File Number: 10-C-24-IH

Location: 1219 New York Ave. **Parcel ID:** 81 o b 015
Zoning: RN-2 (Single-Family Residential Neighborhood)
Description: New primary structure

Level III Subdivision/Plat, New Primary Structure

I0-C-24-IH
APPLICATION FOR CERTIFICATE OF APPROPRIATENESS

ROOF PLAN
1/4 IN = 1 FT

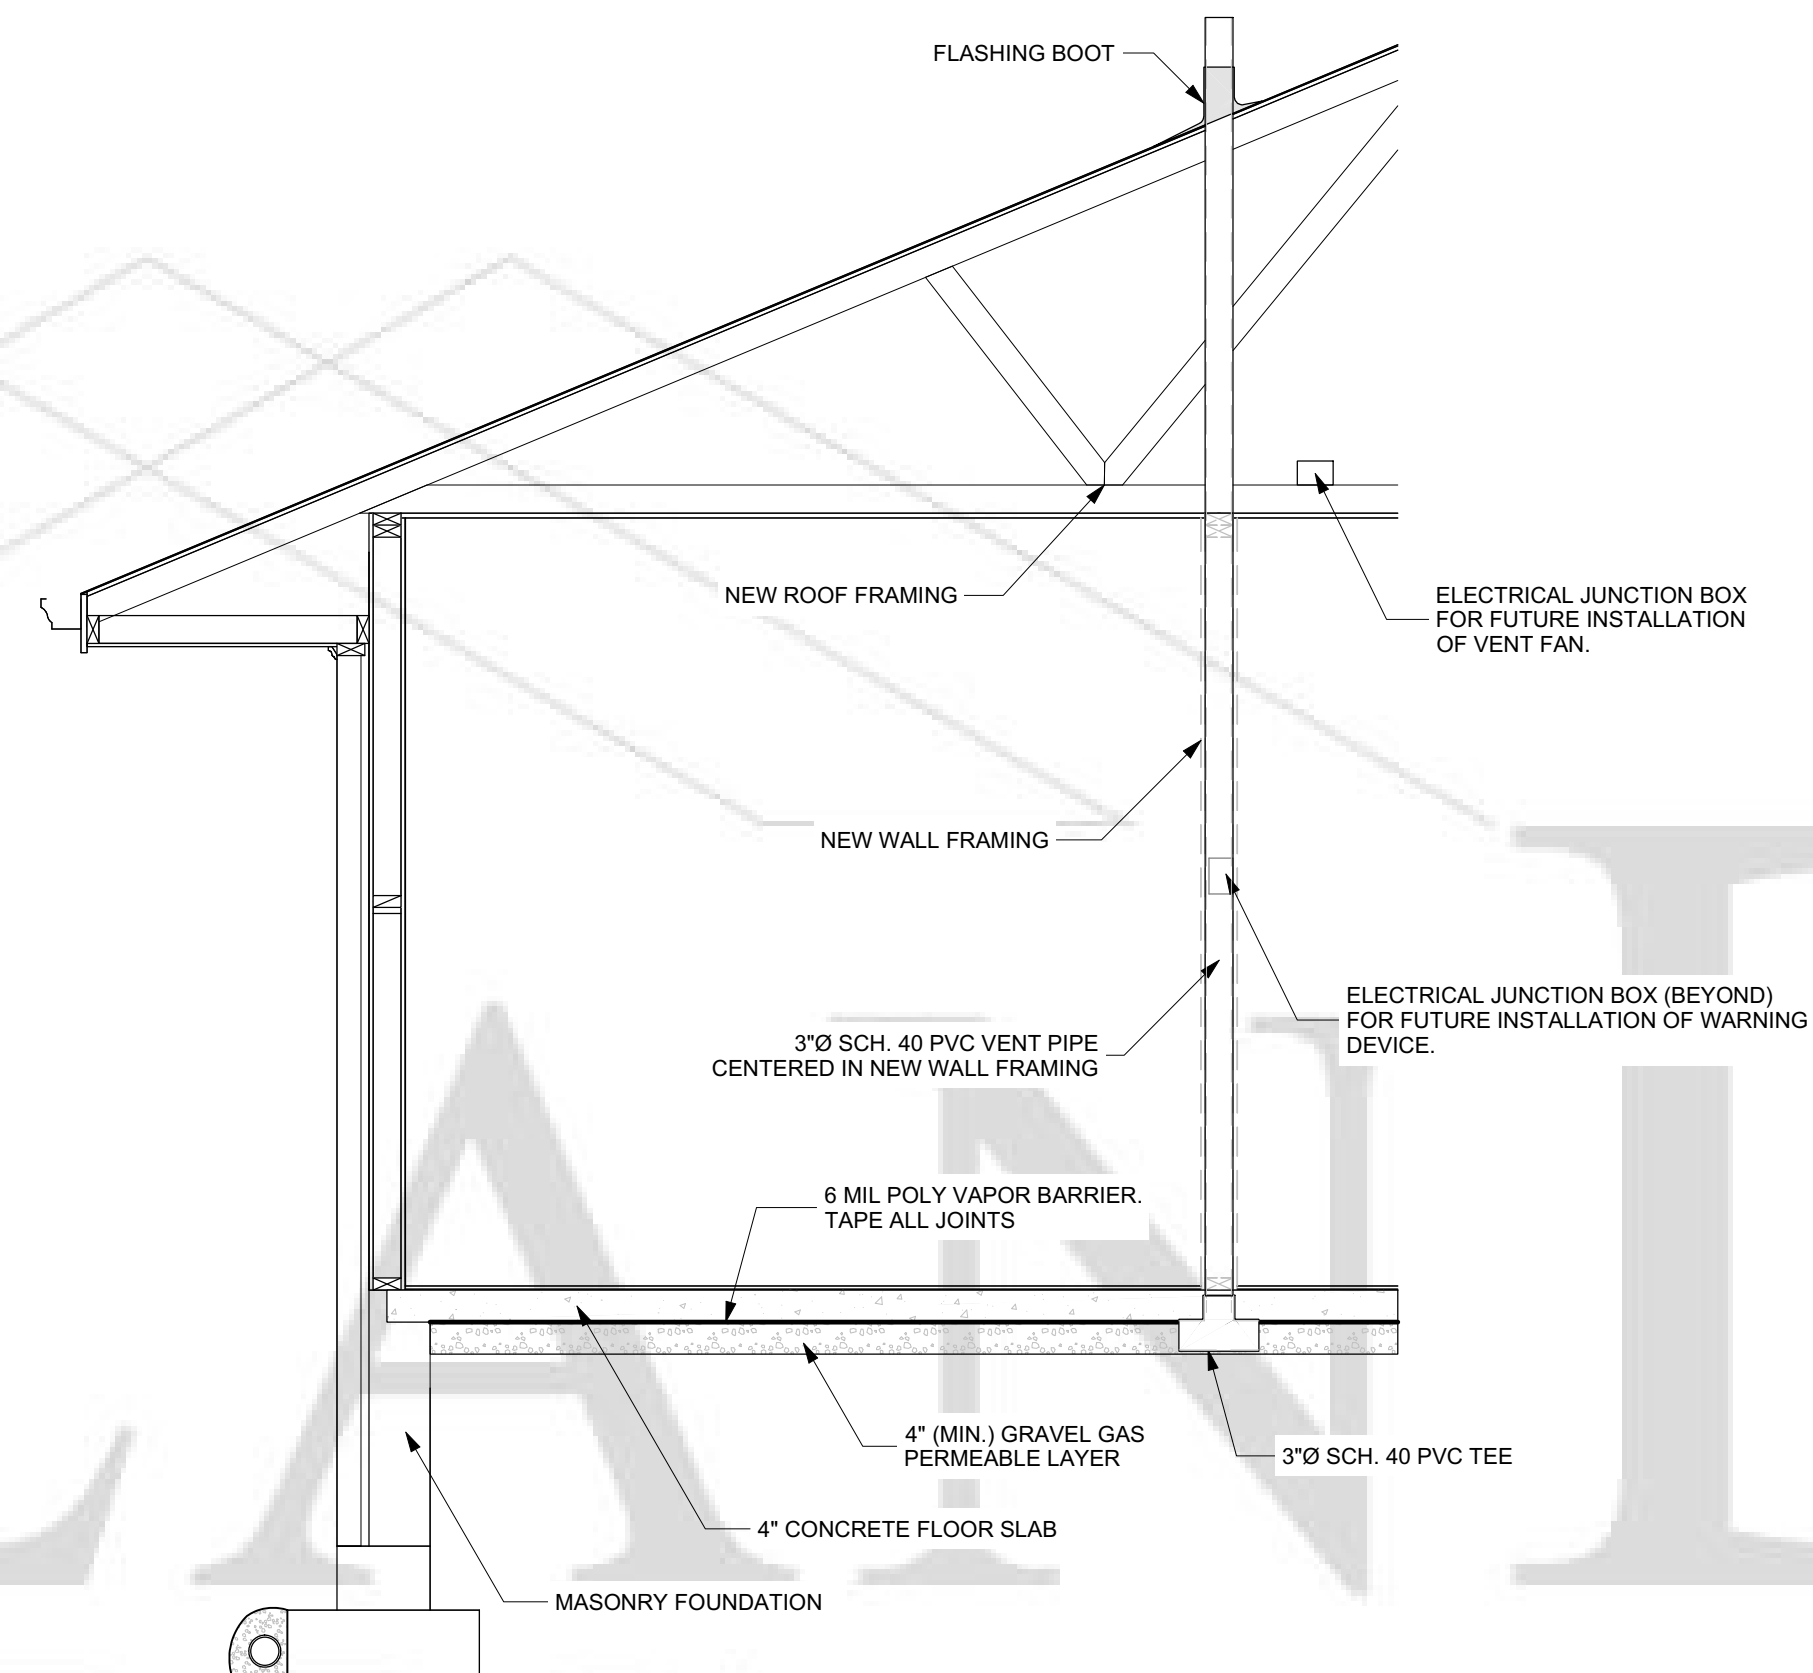
9. The 10/12 pitch front-gable roof meets the design guidelines and features details like rake mold trim, partial cornice returns, and eave overhangs that align with the context. However, the 10/12 pitch is steeper than most of the houses on the block, which are primarily Craftsman bungalows.

REAR ELEVATION
1/8 IN = 1 FT

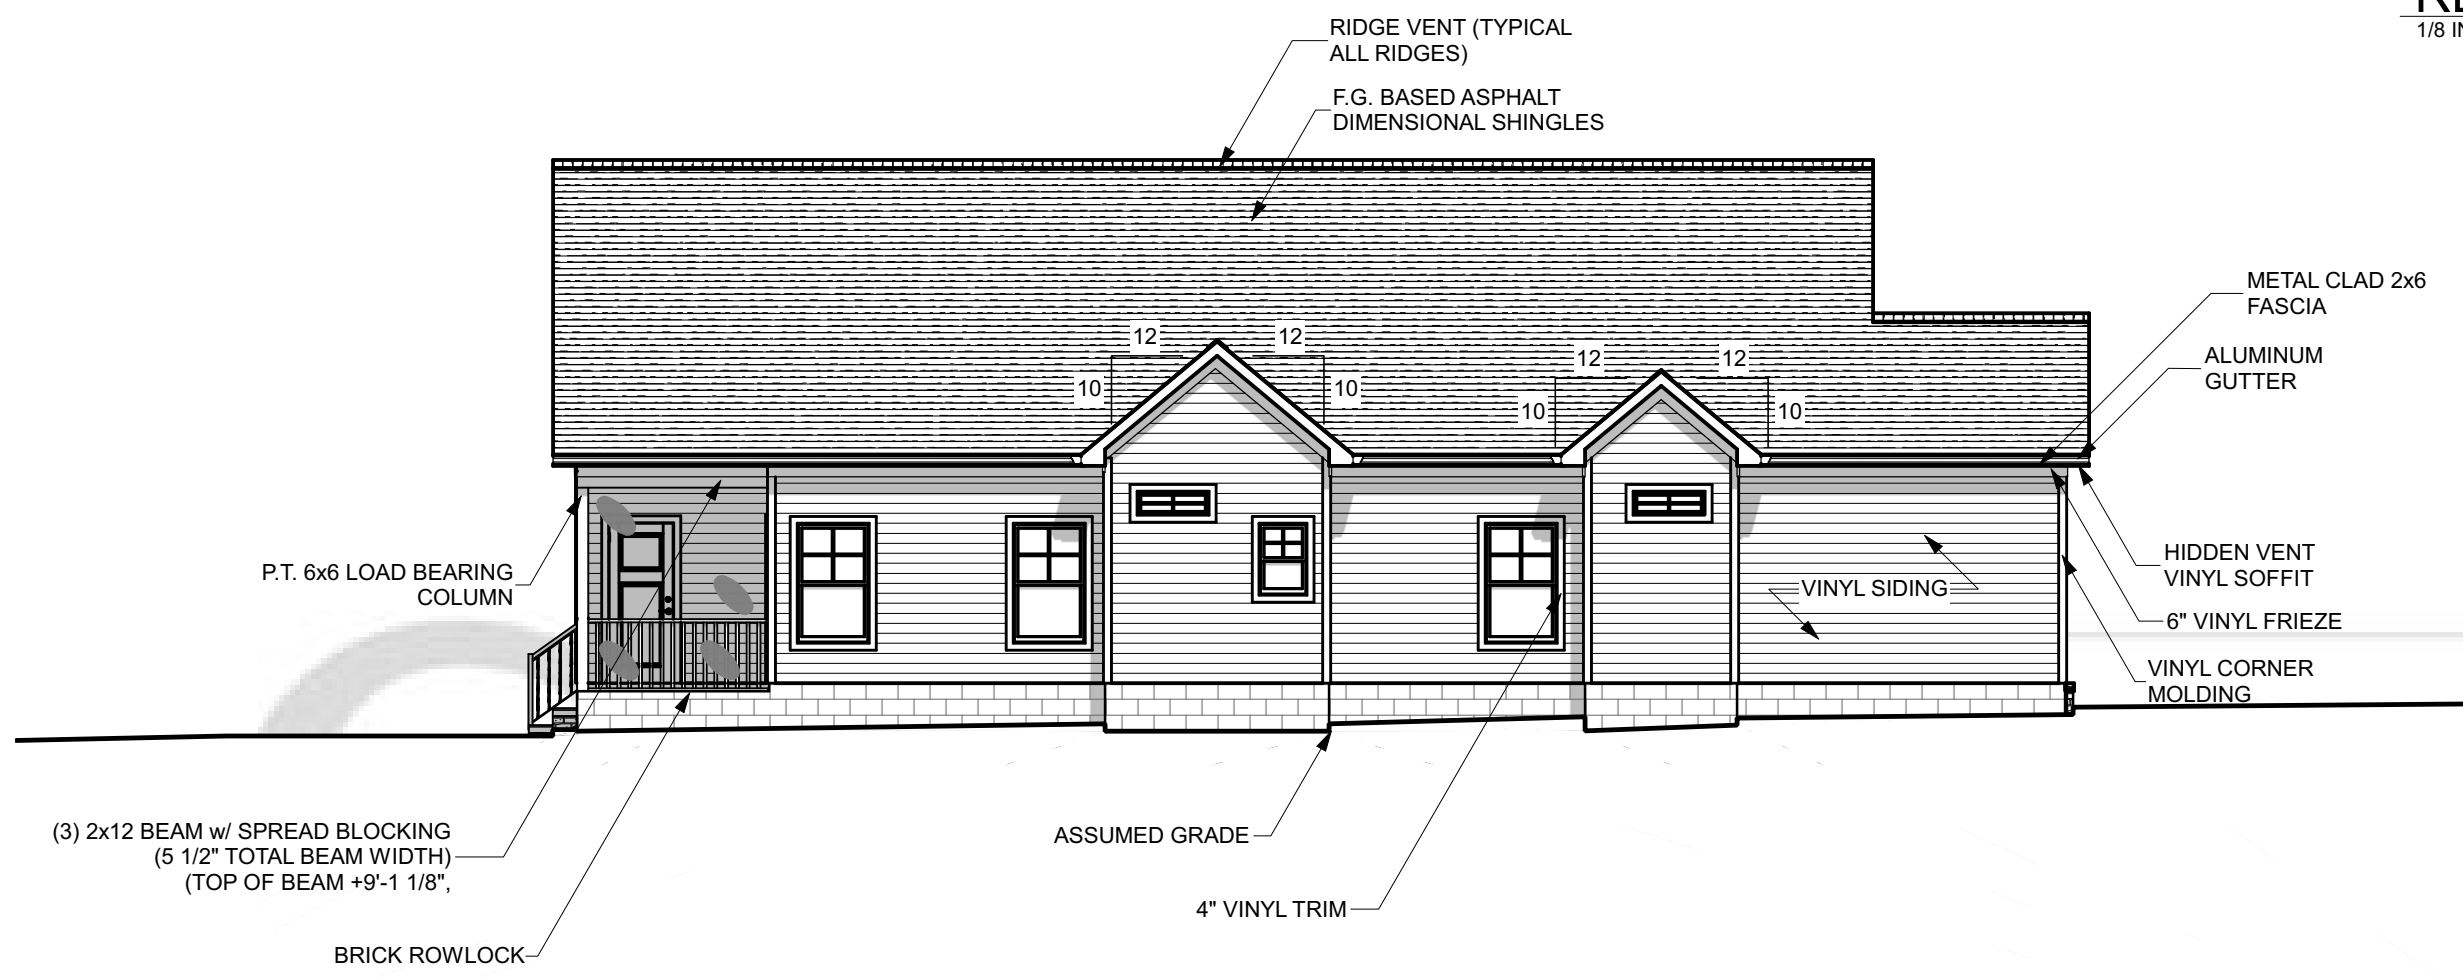
8. Guidelines recommend window and door styles be similar to historic houses on the block with a similar ratio of solid to void. The 4/1 single-hung windows, 4-lite transom windows, and half-lite paneled door are compatible with the context. All elevations feature sufficient transparency, except for the rear elevation which is devoid of windows and will be visible from the side street due to the house's depth. A window should be added to the rear elevation to avoid large swaths of blank siding.

Staff recommends approval of Certificate 10-C-24-IH, subject to the following conditions: 1) the front setback be between 16'-26' and be included on the final site plan; 2) the final site plan to meet City Engineering standards; 3) the front porch depth be increased to 8', with revised elevations provided if a handrailing is required during permitting; 4) one window be added to the rear elevation; 5) the primary siding material on the façade be revised to horizontal siding, using board and batten as an accent only, and depicted in revised elevation drawings; 6) the foundation on the side and rear elevations to be clad in brick veneer, parge coated, or clad in stucco; and 7) retaining rake mold trim, partial cornice returns, and eave overhangs as depicted.

FRONT ELEVATION
1/4 IN = 1 FT

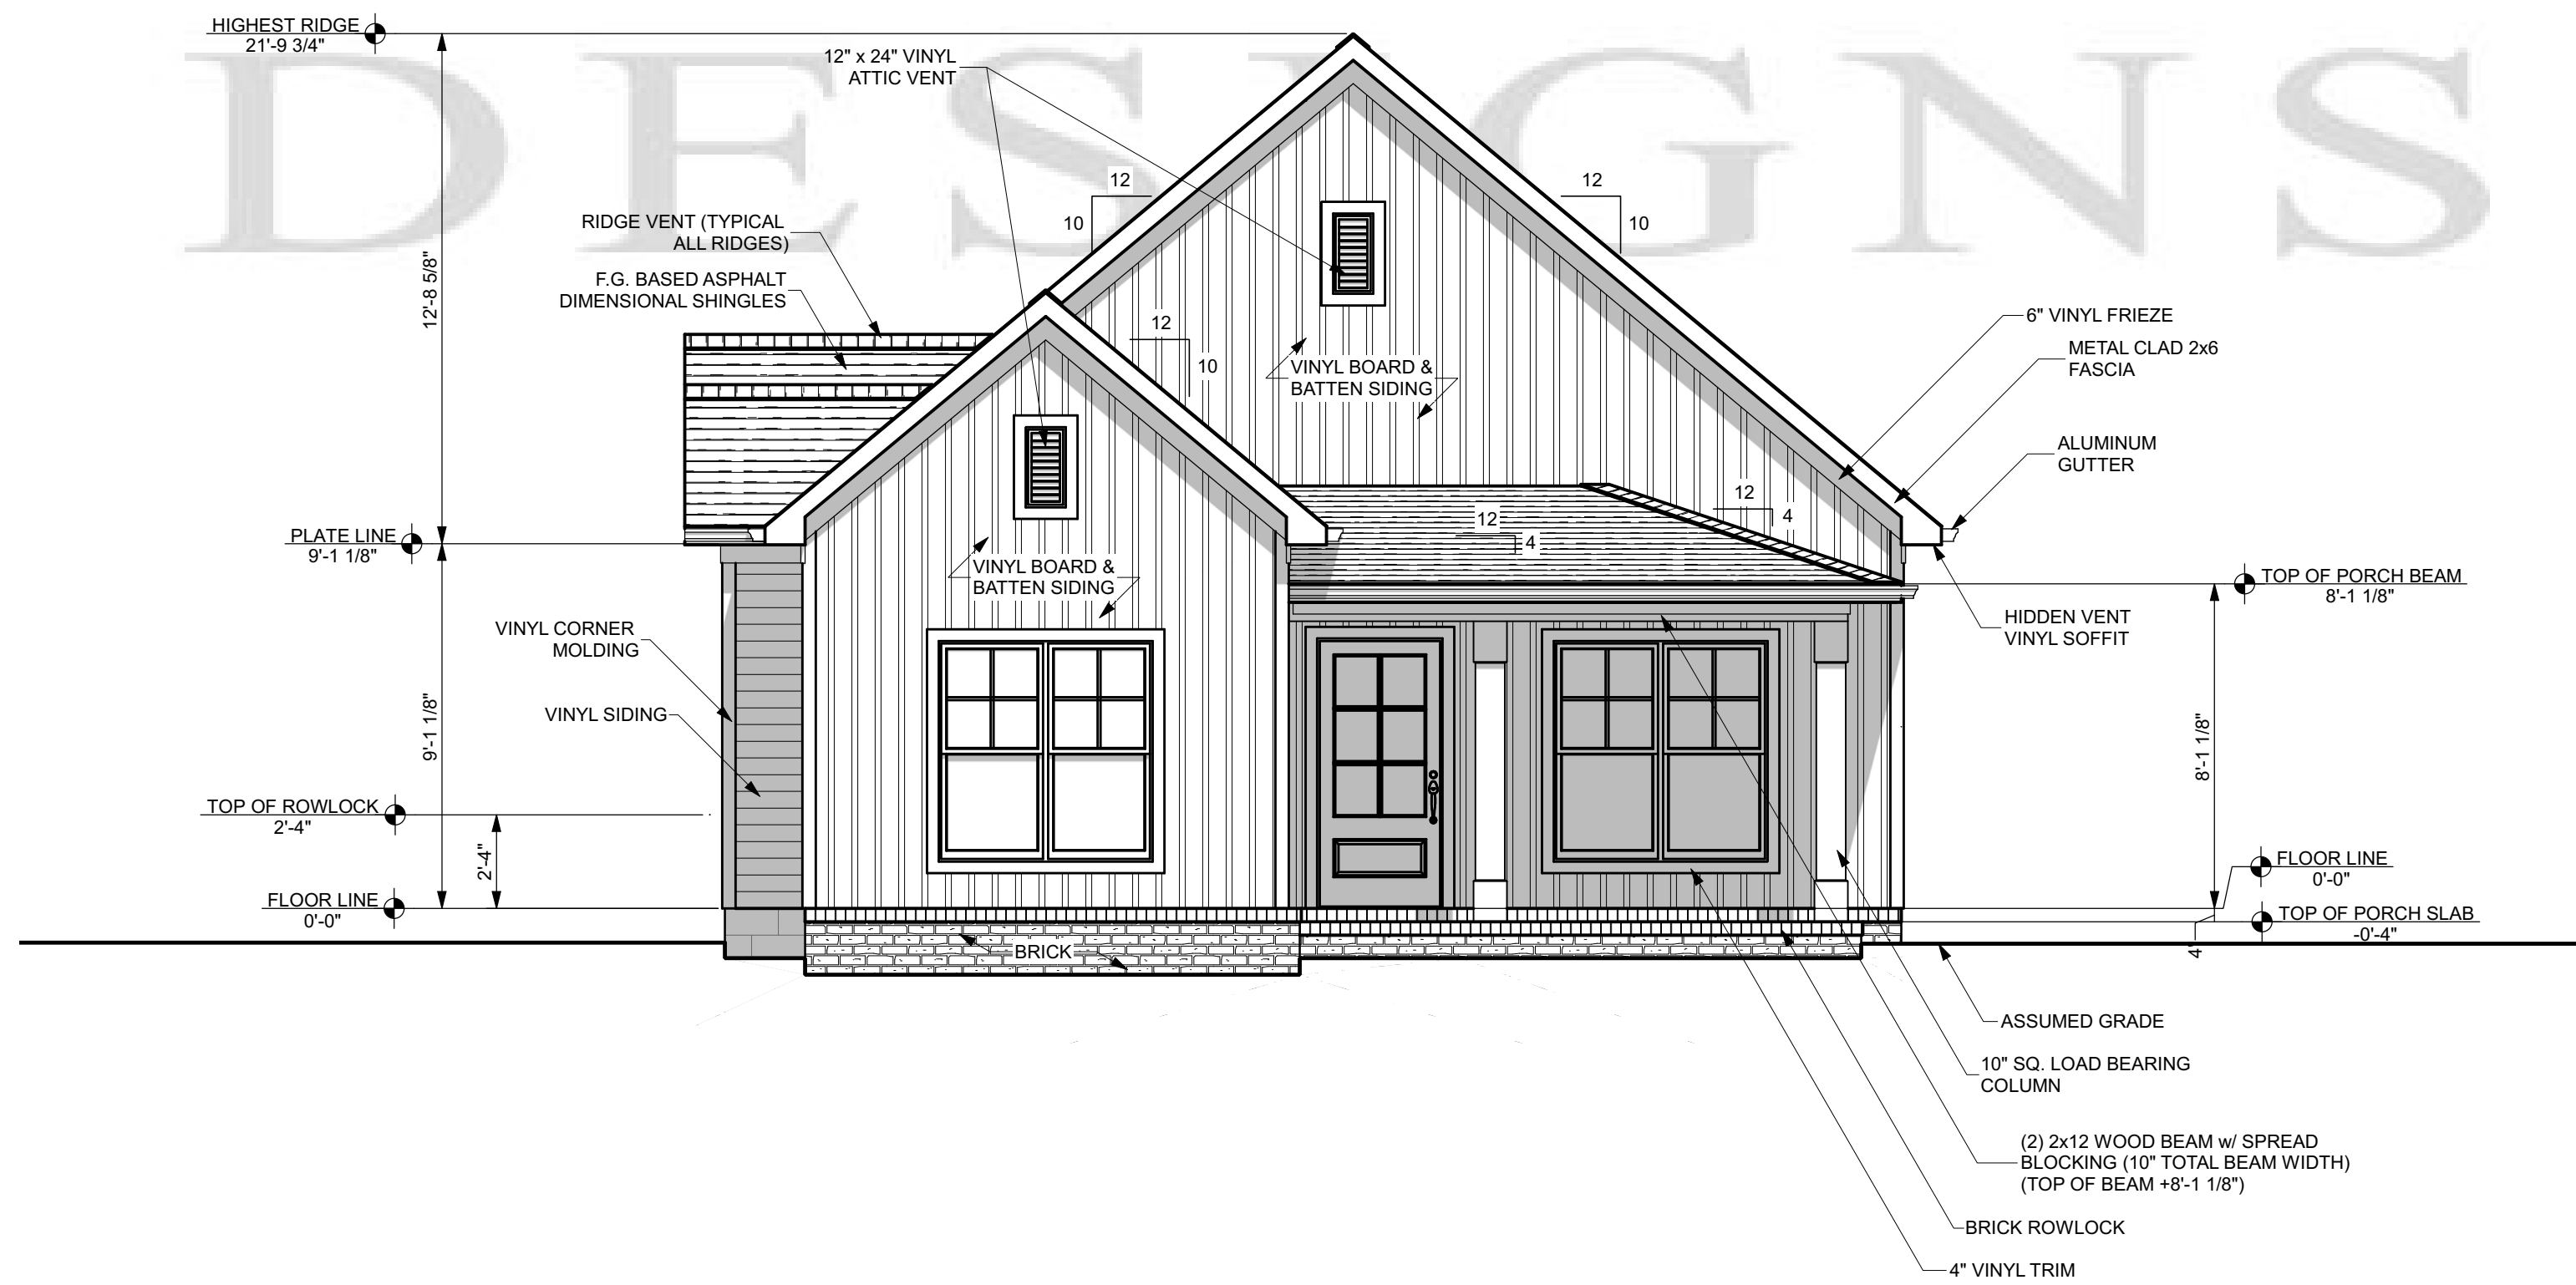
6. The three-bay one-story façade is similar in scale and height to the other houses on the block, which are primarily one-story.
7. The design features a 5'-7" deep half-length front porch recessed under a partial hipped roof supported by two 10" square columns, which is similar in scale and design to others on the block. However, the depth should be increased to 8' to meet the design guidelines. If a handrailing is added to meet code requirements, it should be depicted on the final elevation drawings, to be approved by staff.

siding and the use of different primary siding materials across elevations, and board-and-batten siding is typically approved as an accent only. The primary siding material on the façade should be revised to horizontal siding, with board-and-batten used as an accent only, and revised elevation drawings should be provided. The façade features brick veneer cladding on the block foundation. The foundation on the side and rear elevations should be clad in brick veneer, parge coated, or clad in stucco to meet the design guidelines.
